Total: 2 pages  
Date: 17 July 2025  
TPB Ref.: A/YL-LFS/560

**Proposed Temporary Open Storage of Elevated Working Platform for a Period of 3 Years at Lots 2035 RP (Part), 2036 RP (Part), 2037 (Part), 2038 (Part), 2039 (Part), 2040 RP, 2042 RP (Part), 2049 (Part) & 2052 (Part) in D.D. 129, Lau Fau Shan, Yuen Long, N.T.**

Our response to the comments of the AMO is found below:

Figure 4

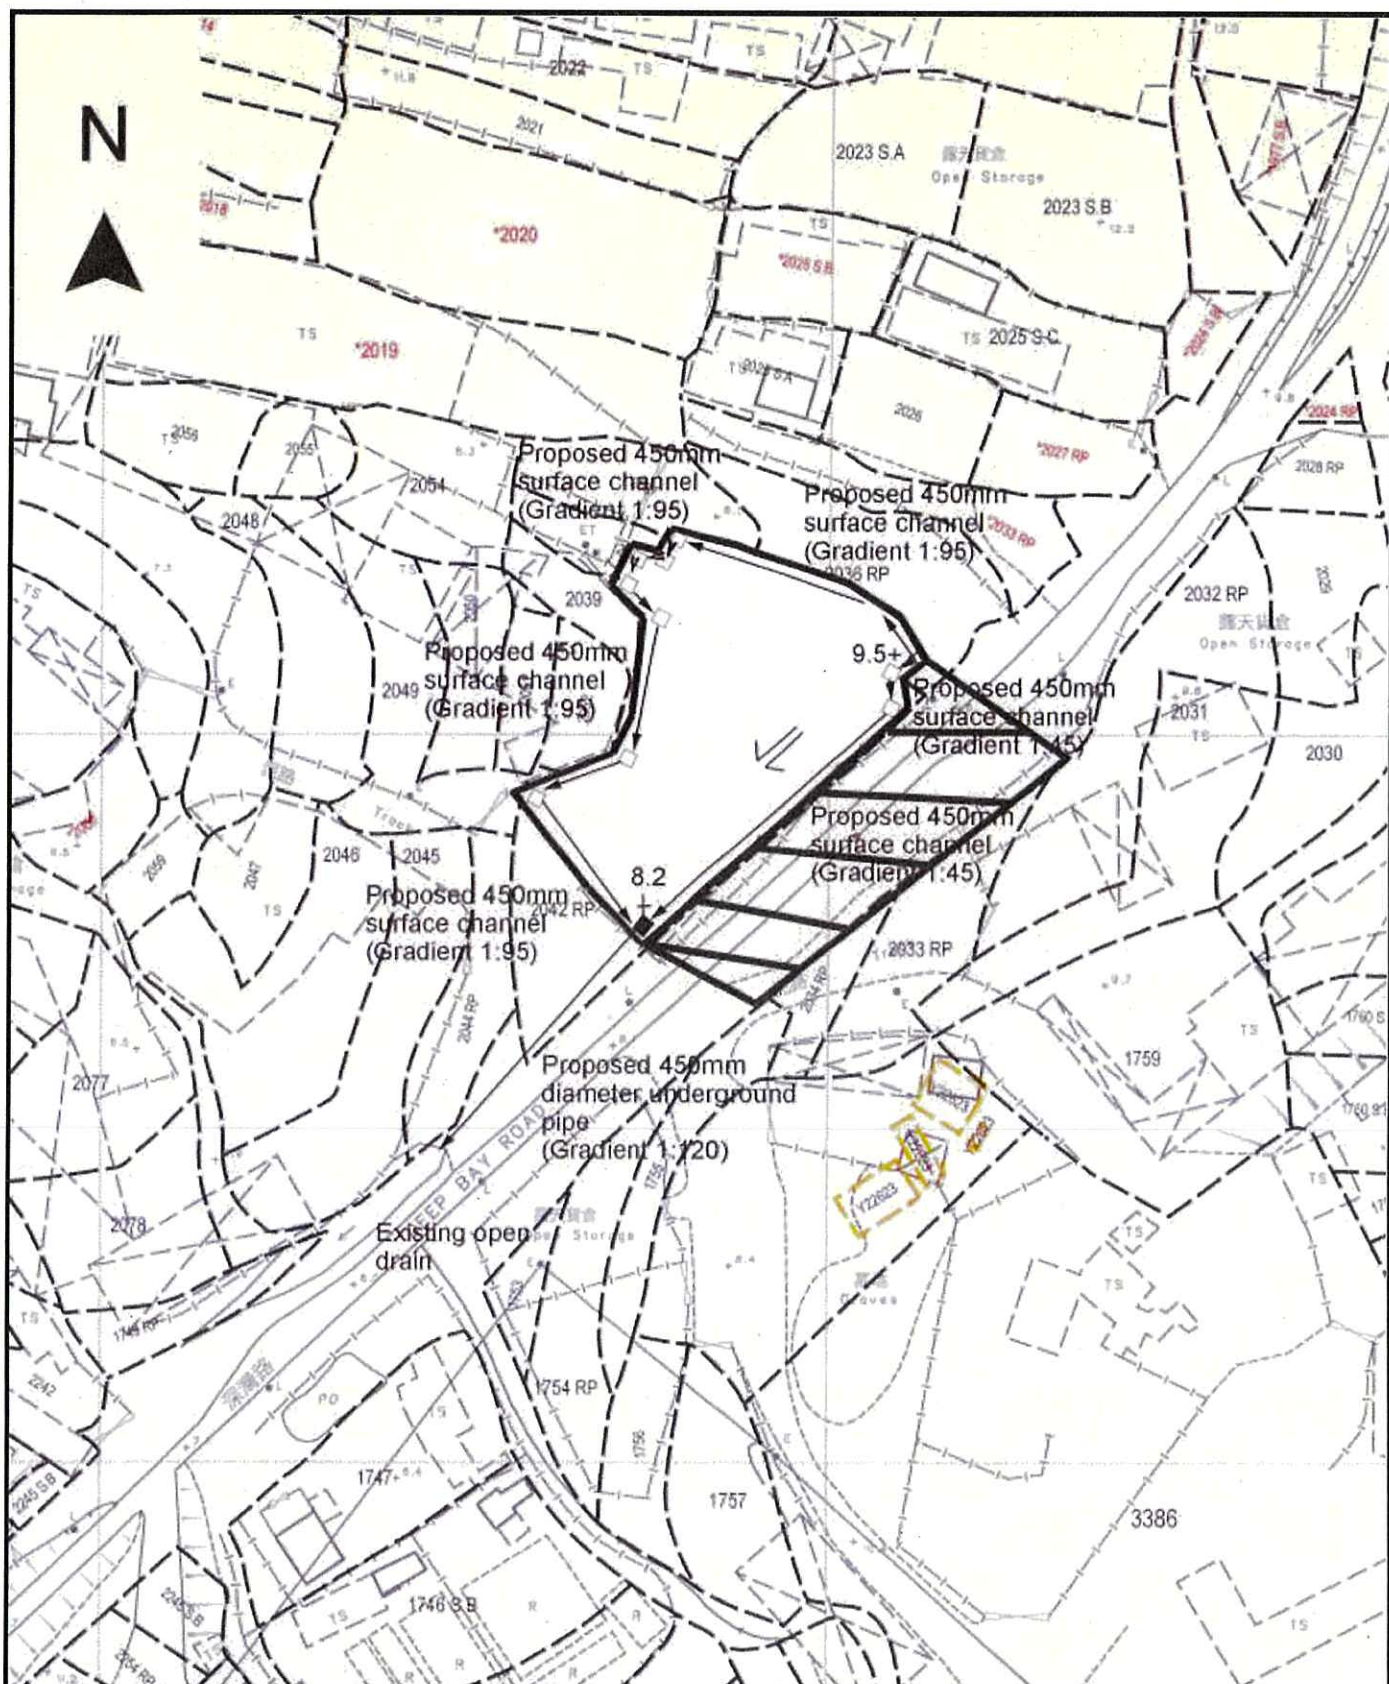
AMO's comments	Applicant's response
Please note that the application site is situated within the Lau Fau Shan Site of Archaeological Interest. According to the submission, drainage facilities are proposed to be built along the site periphery. The applicant is, therefore, required to provide details of the proposed works, e.g. the location, <u>extent and depth</u> of the proposed ground excavation and previous site formation works for AMO's comment and agreement before commencement of the proposed work	We confirm that excavation will be carried out at the application site for the provision of surface channel to the satisfaction of the Drainage Services Department. The location of the excavation is shown in the attached drainage plan along the site periphery. The depth of excavation will be 450mm. No site formation works will be carried out at the application site.
